EXTRA O-RING REMOVED FROM HIGH PRESSURE CONTROL VALVE TOPWORKS

This product notice is to inform you that we are removing an extra O-Ring from our High Pressure Control Valve Topworks.

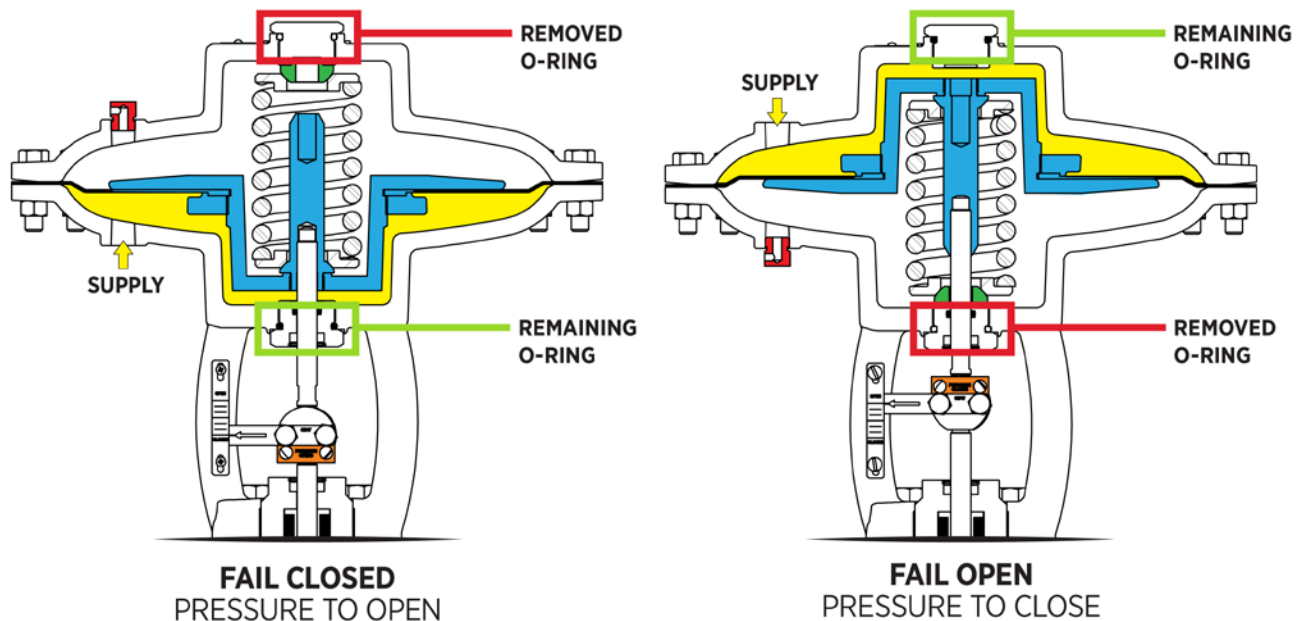
Kimray High Pressure Control Valves feature a field-reversible topworks that can be configured to meet your specific control needs. In the past, an extra O-Ring was included on the atmospheric side of the topworks for a product that has since been discontinued.

This change eliminates the extra O-Ring on the atmospheric side. Associated repair kits will also include one less O-Ring.

One O-Ring will continue to be necessary on the supply side depending on whether your topworks is configured to fail closed (pressure to open) or fail open (pressure to close).
